AGENDA
La Vergne Planning Commission
September 26, 2023 at 6:00 PM

MINUTES OF THE REGULAR MEETING OF THE CITY OF LA VERGNE PLANNING COMMISSION HELD ON AUGUST 29, 2023 AT LA VERGNE CITY HALL, LA VERGNE, TENNESSEE.

SITE PLAN

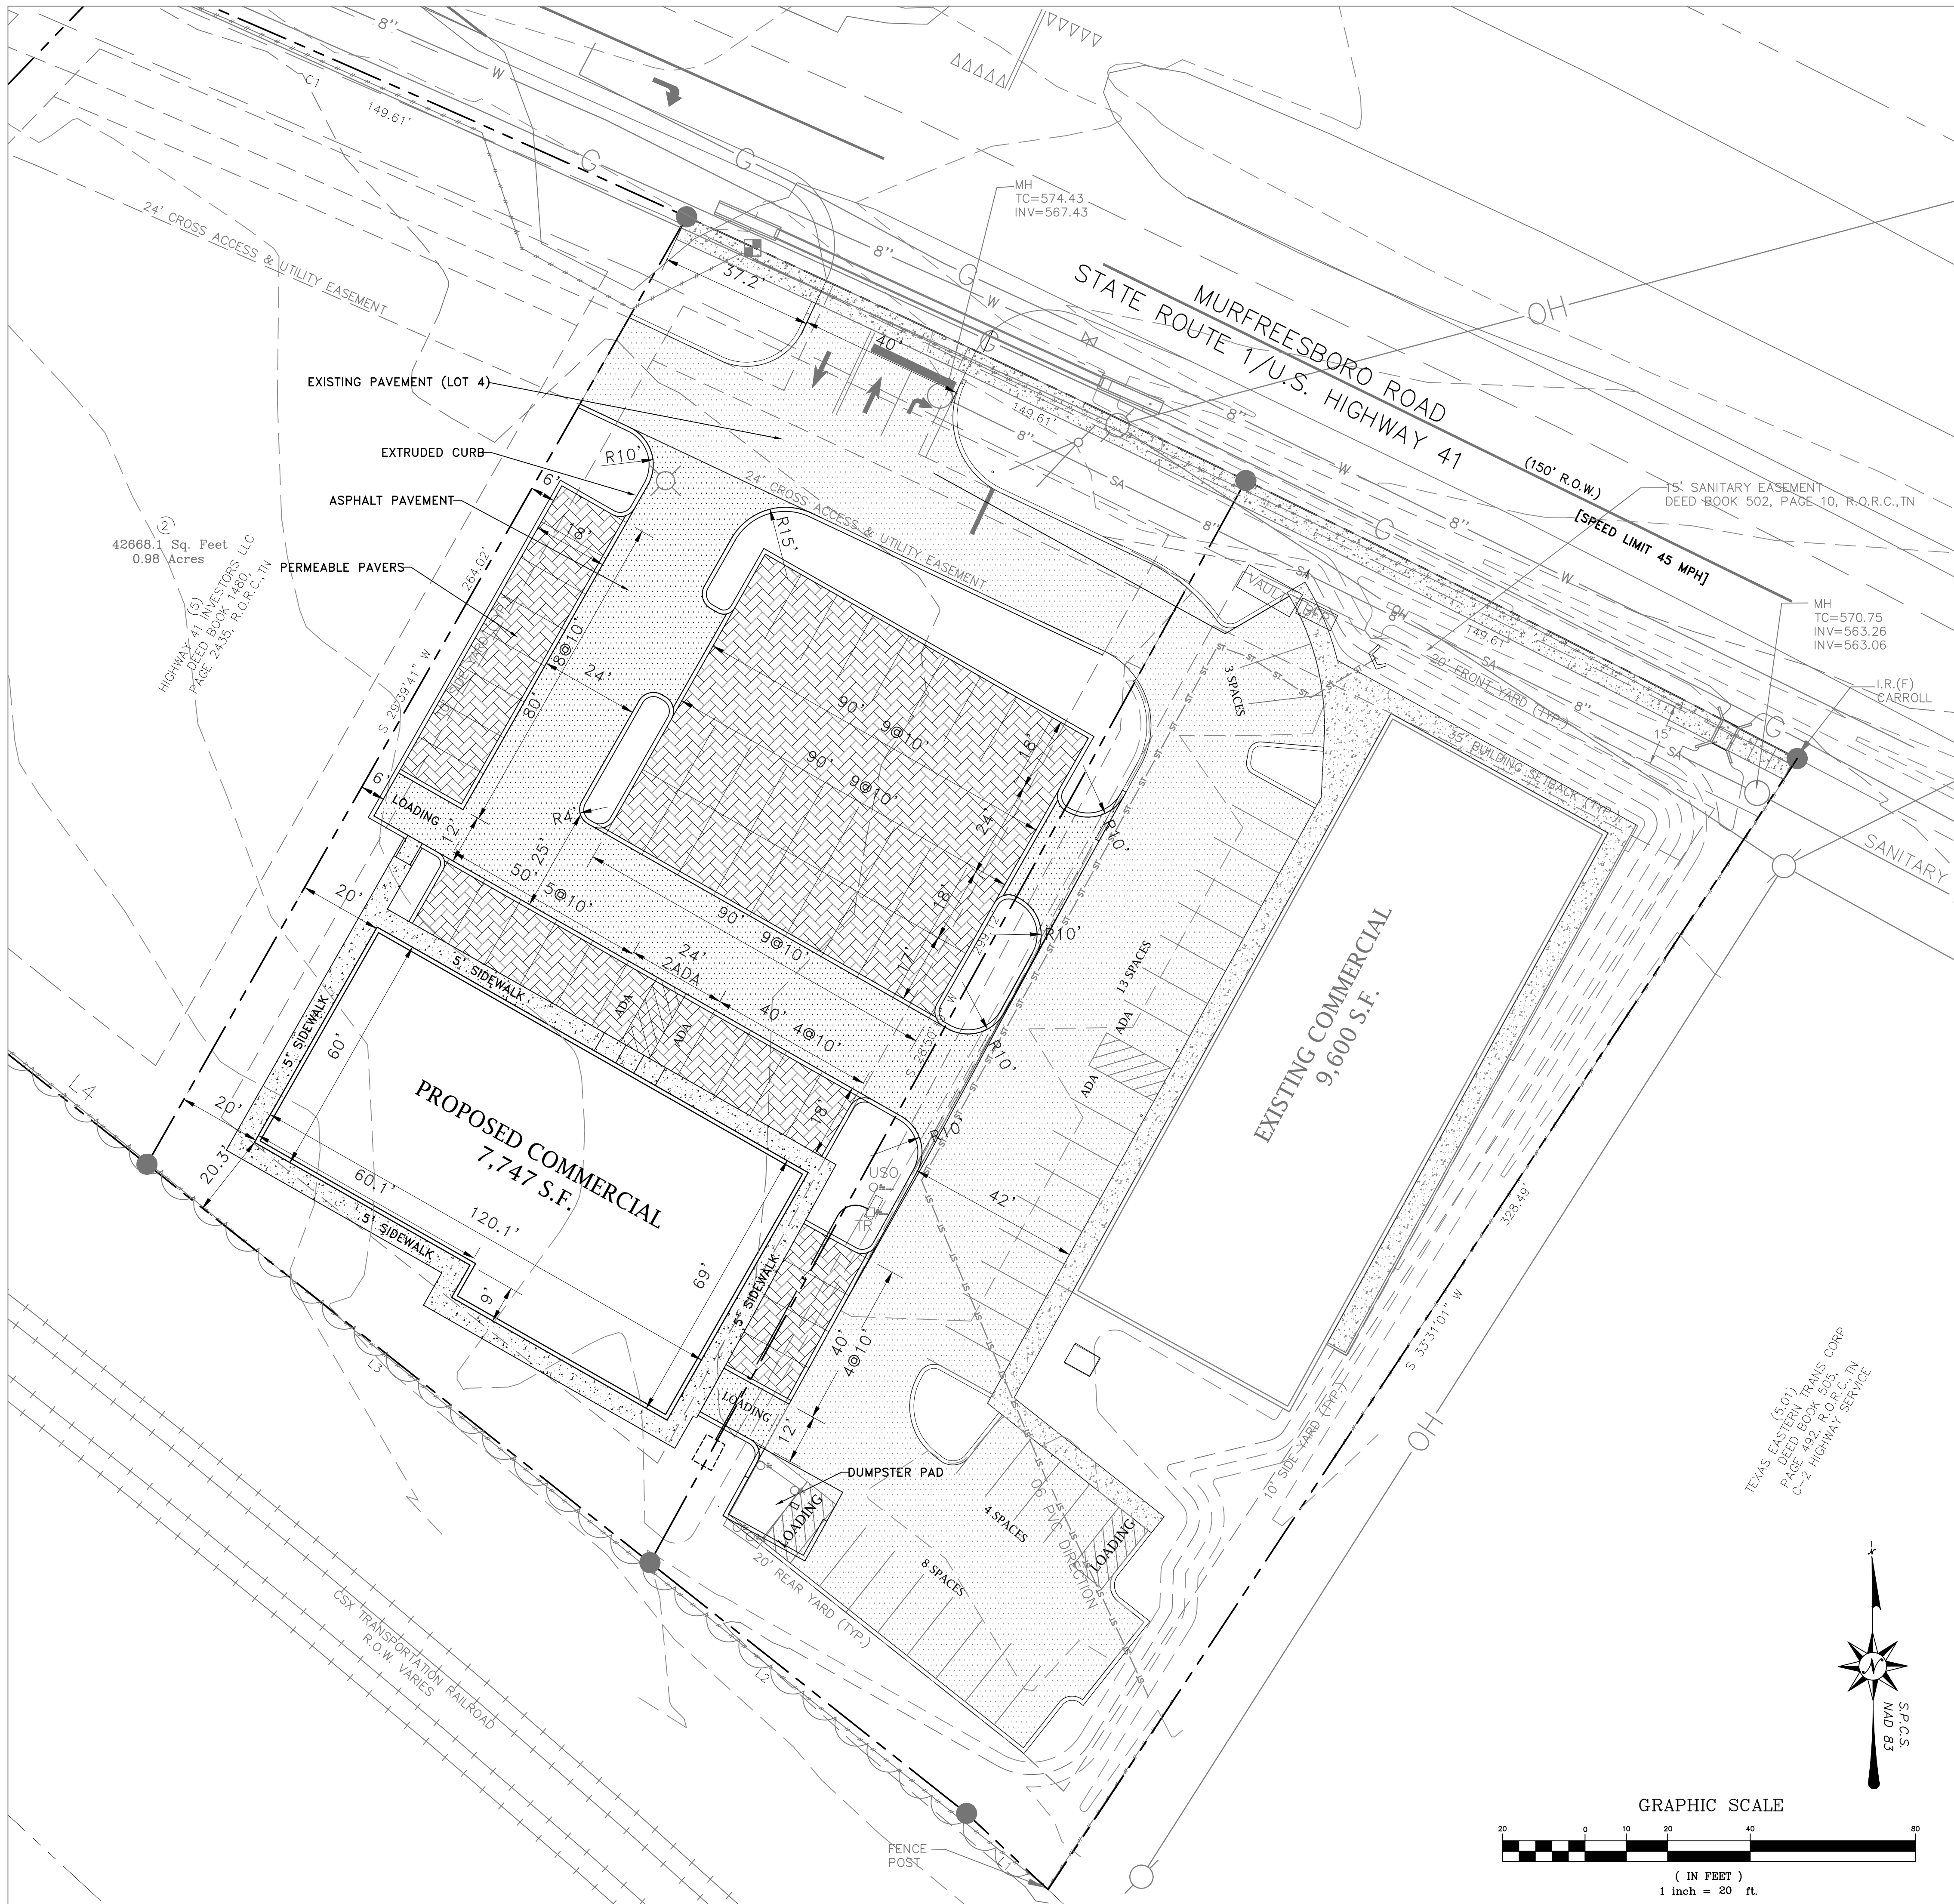
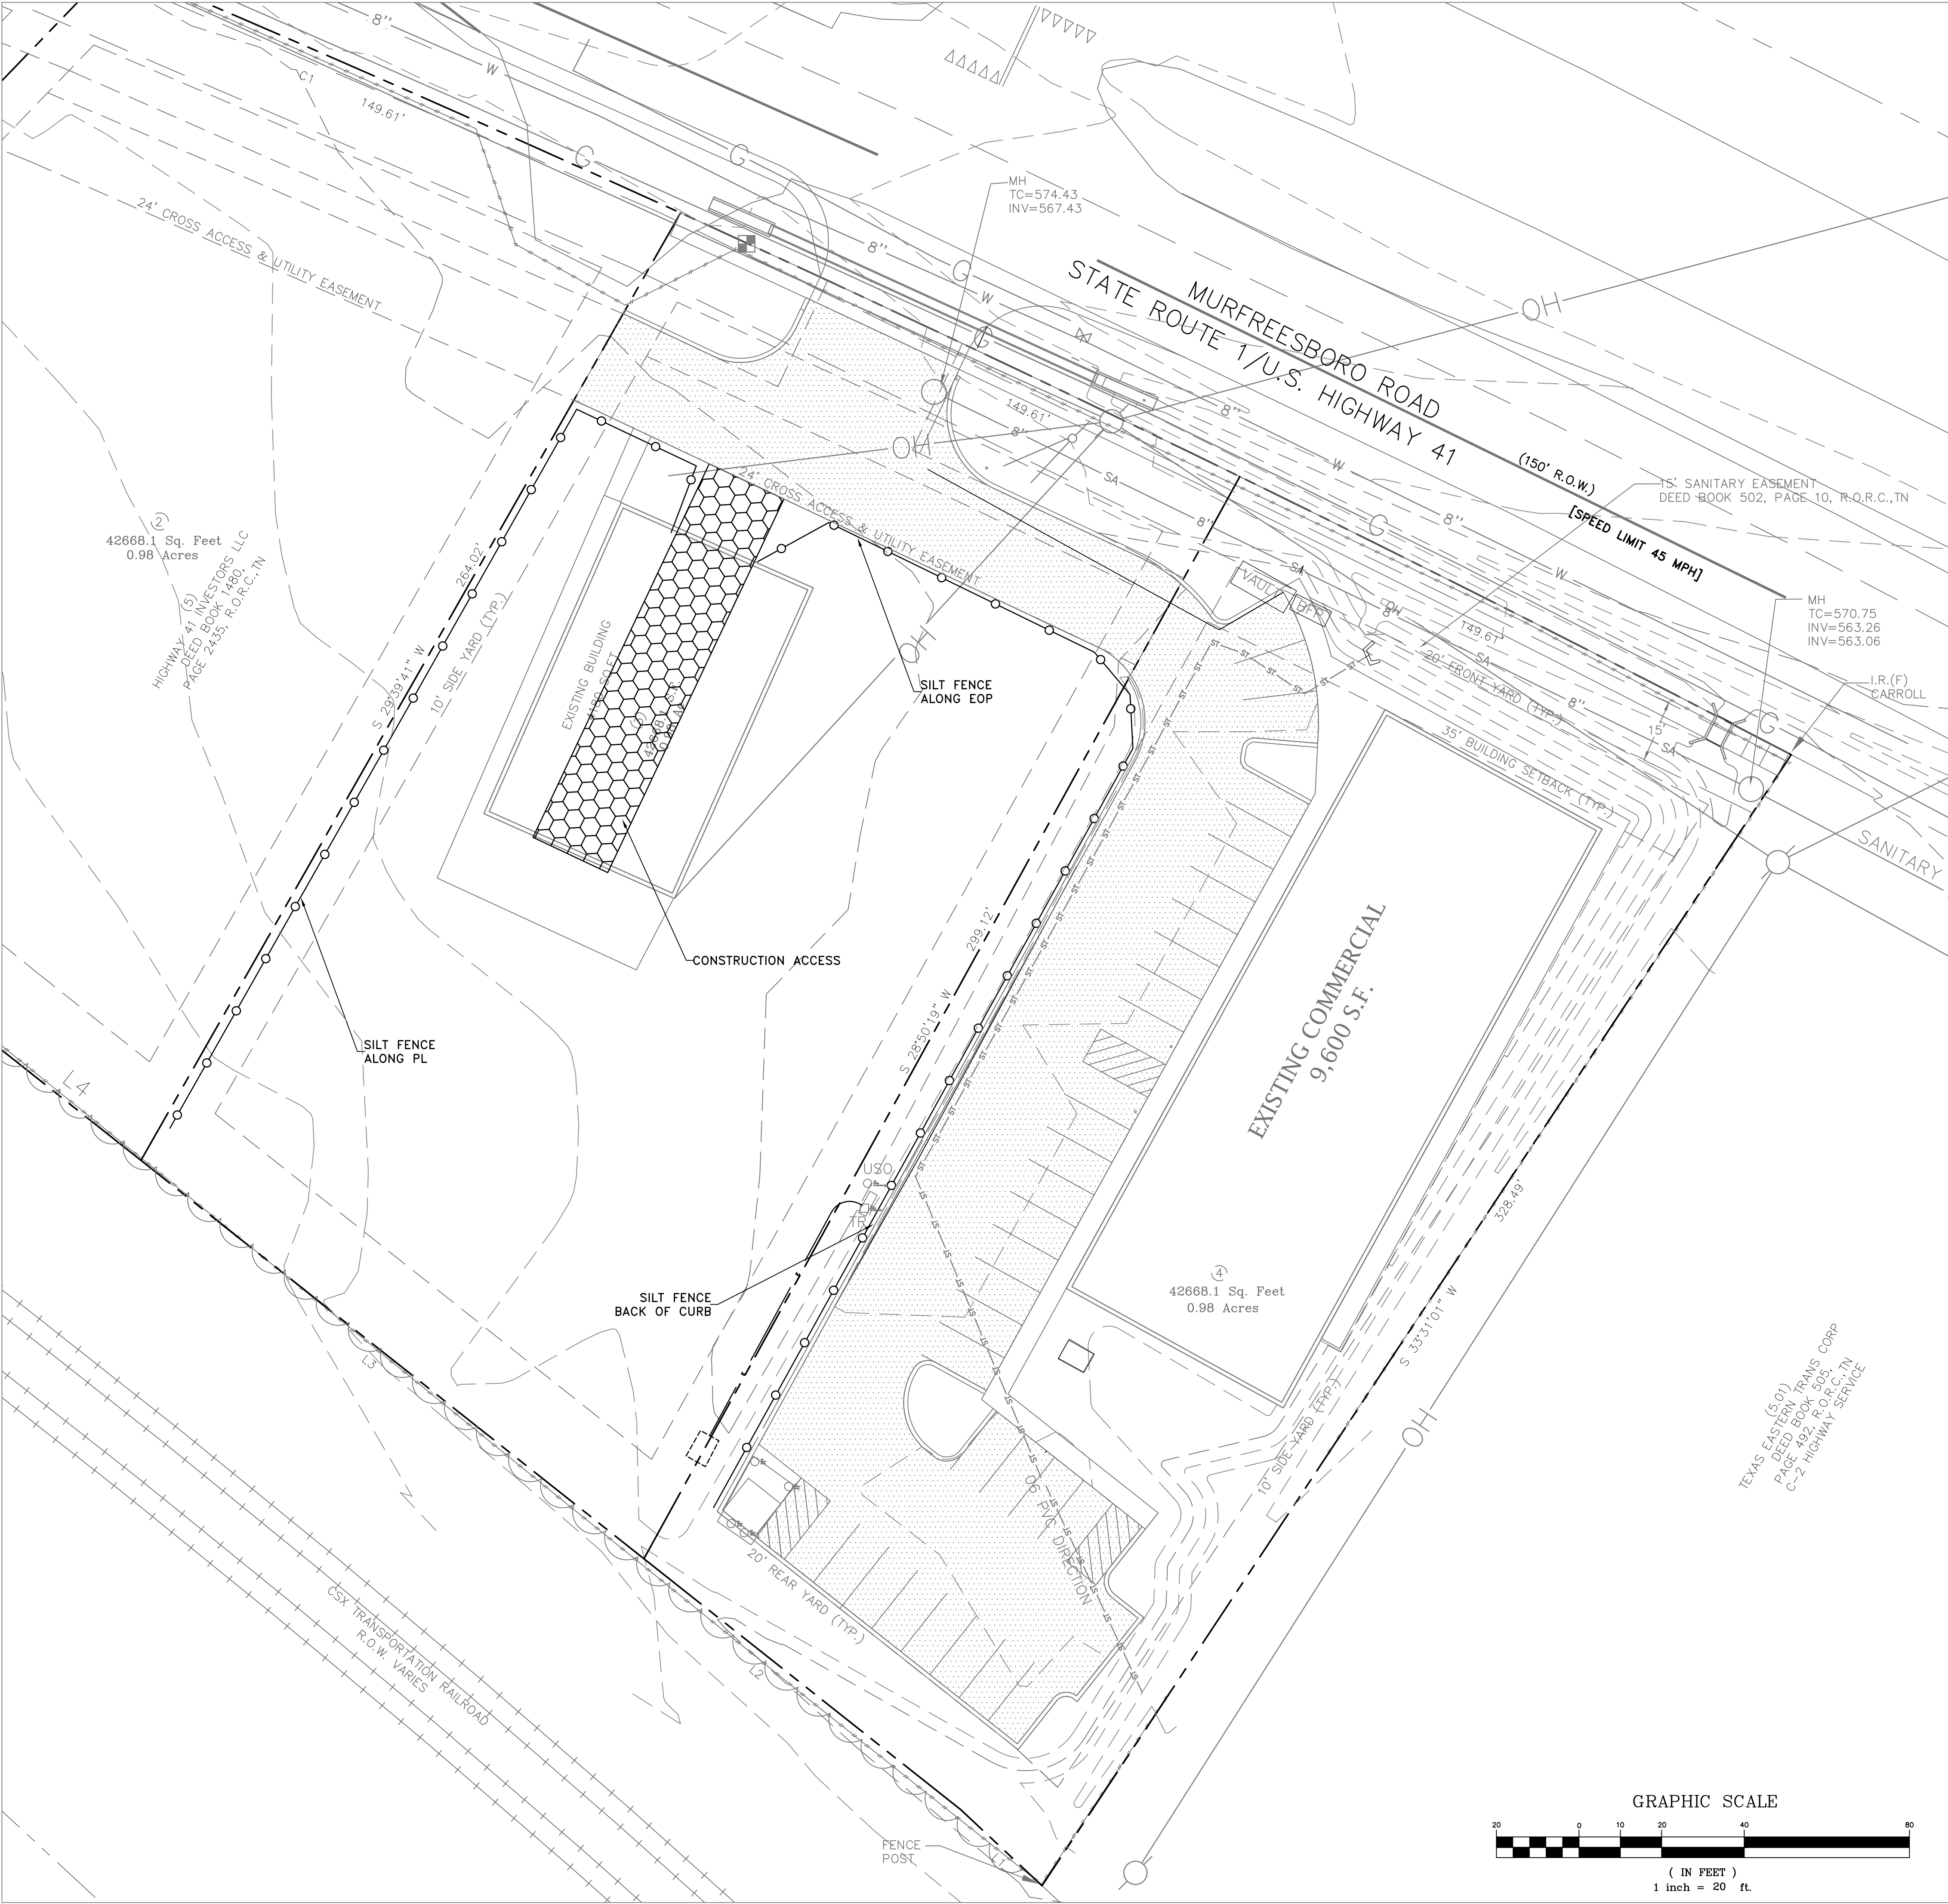
1. (C2.1) The Planning Commission requested that the engineer look at aligning the exit from the parking area with Murfreesboro Road ramp. This was not changed. Please provide explanation to the Planning Commission at the meeting.
2. (C2.1) For Planning Commission Information Only: The dumpster pad has been modified by the engineer with the new wall location shown. The new dumpster layout will have room for three dumpsters. The wall may have to be field-rotated slightly to match existing curb line and maintain the eight parking spaces shown.

Sheet C0.0
Industrial Blvd
S.E.C. Project #22028
Submitted: 8-1-2022
Revised:

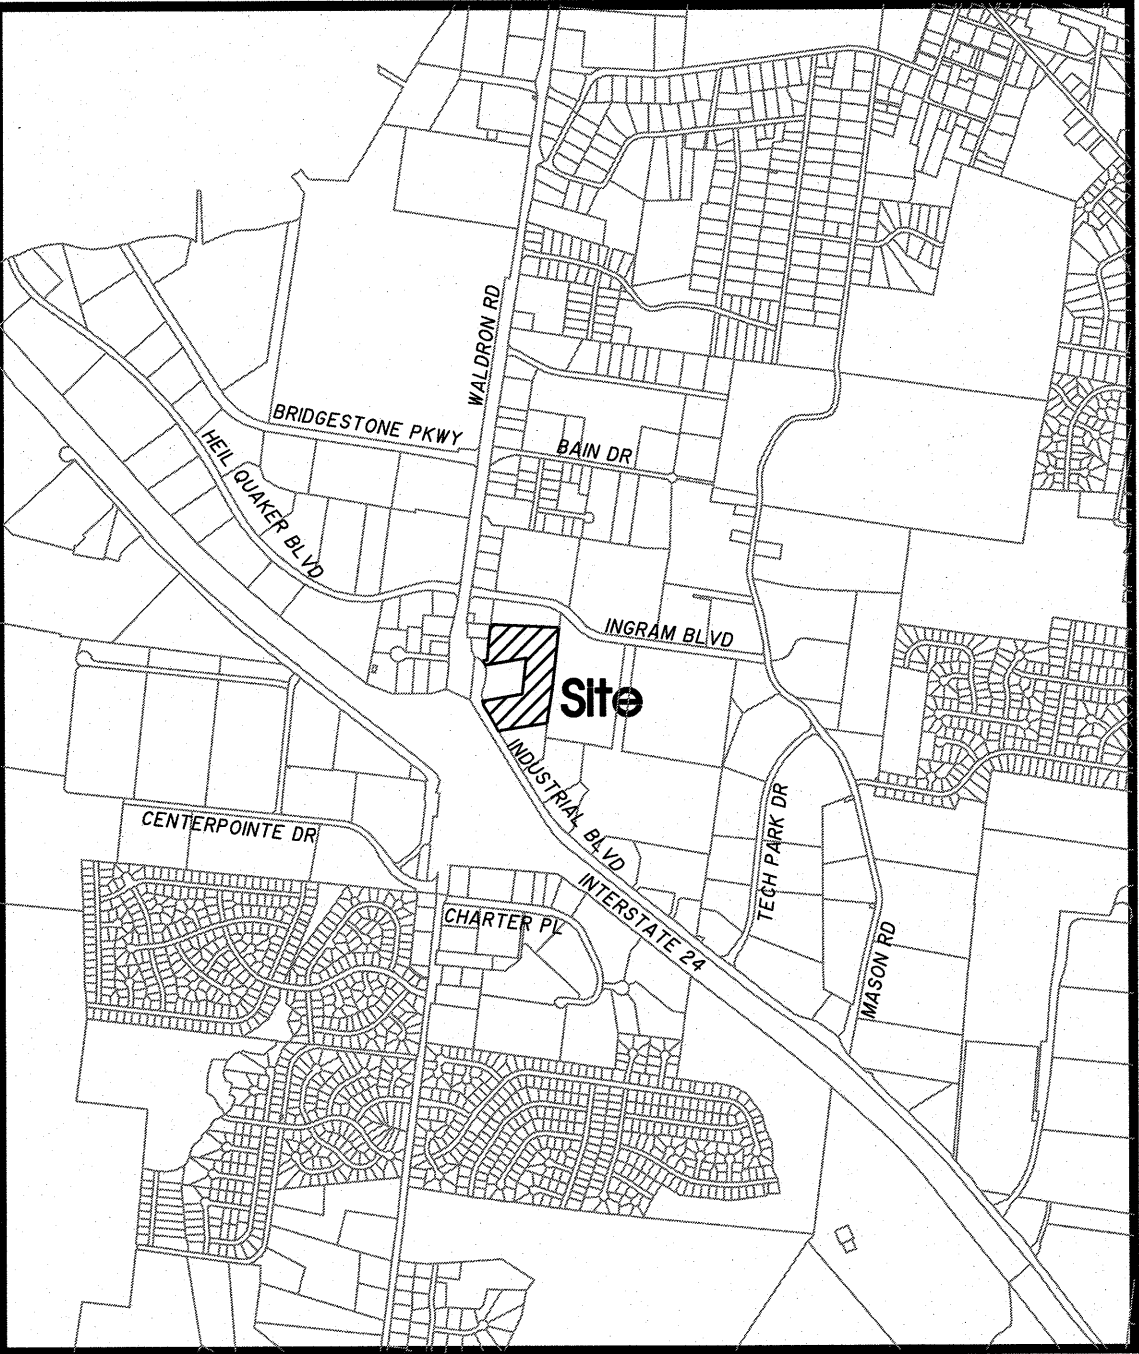
1. **(Sheet 0.0) City requests that the name of the plans be changed to something more site specific such as '131 Industrial Blvd' to assist with filing. Coordinate with City Planner.**
2. **(Sheet C0.0) Update FEMA map reference to 2023 map which has been adopted by the City.**
3. **(Sheets C1.1, C2.0, A4.00, and A 4.01) Provide more detail on site plan regarding what is happening with the existing building. Coordinate with Fire Marshal regarding whether**
